RONJA

Reducing minimum communication distance

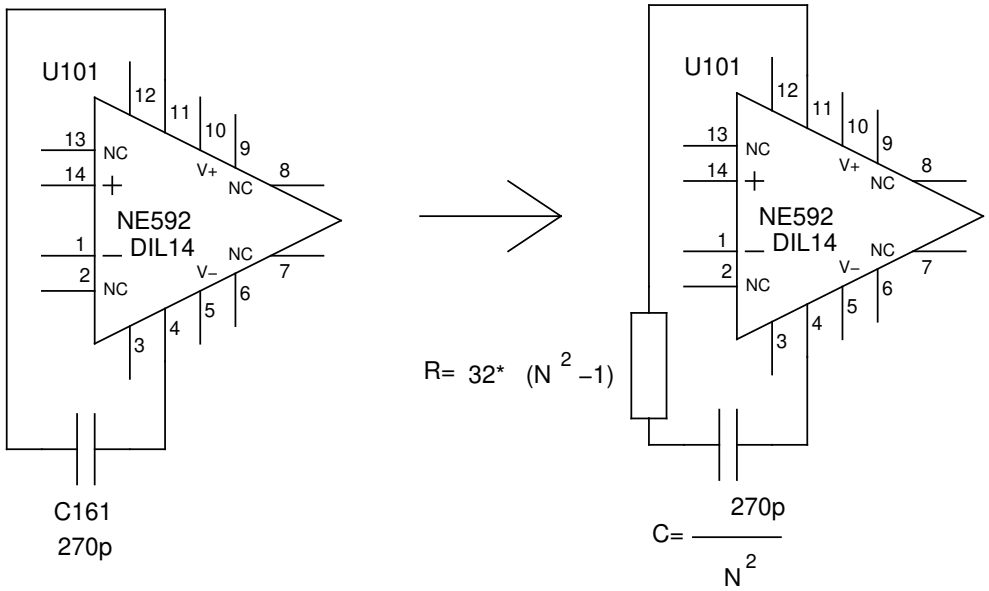
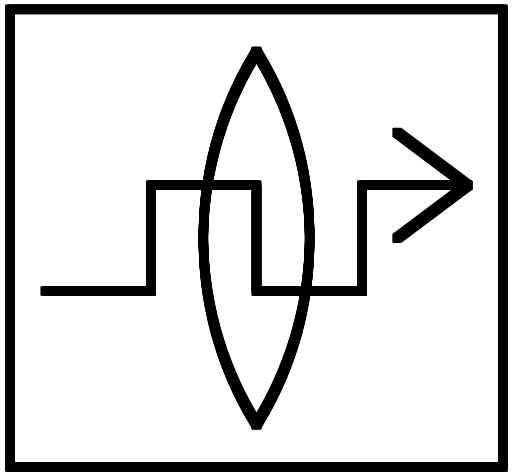
Change in 10M Receiver or Inferno Receiver:

N=how many times we want to reduce minimum distance.

Example: we want to reduce minimum distance

from 90m to 45m. Then N=2.
